# Technical Service Bulletin

Model	MC / HD / NF / TG / JM / EN
Group	BRAKE SYSTEM
Number	91B026

**STOP LAMP SWITCH REPLACEMENT**

Date	JULY, 2009
Area	Puerto Rico
Type	Safety Recall

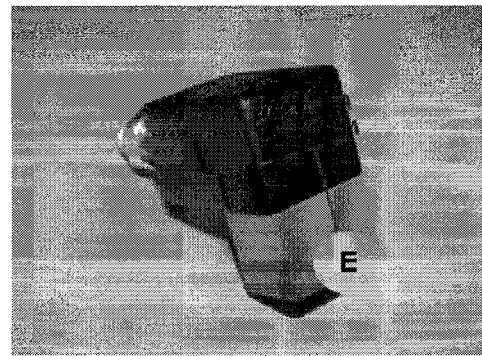
- Before installing the replacement part, be sure to check the part number (E).
- If old part number is 93810-3K000 or 93810-38110, replace it with 93810-3K000QQH.

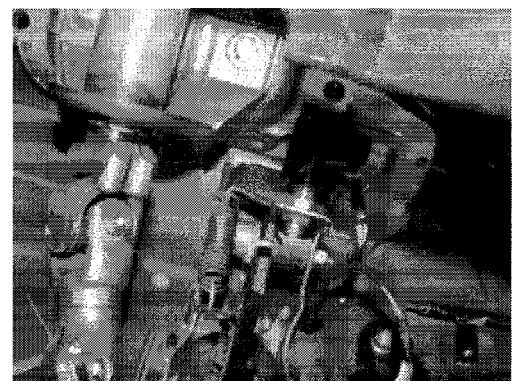
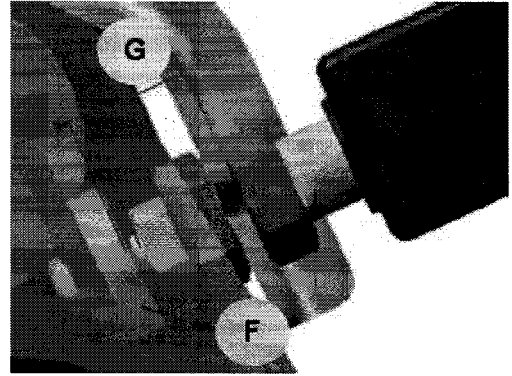
6. Adjust the brake pedal stopper (F) to stop lamp switch clearance (G) to the below specification.  
- Clearance spec.: 1.5 mm ~ 2.0 mm

**-Clearance spec.: 1.5 mm ~ 2.0 mm**
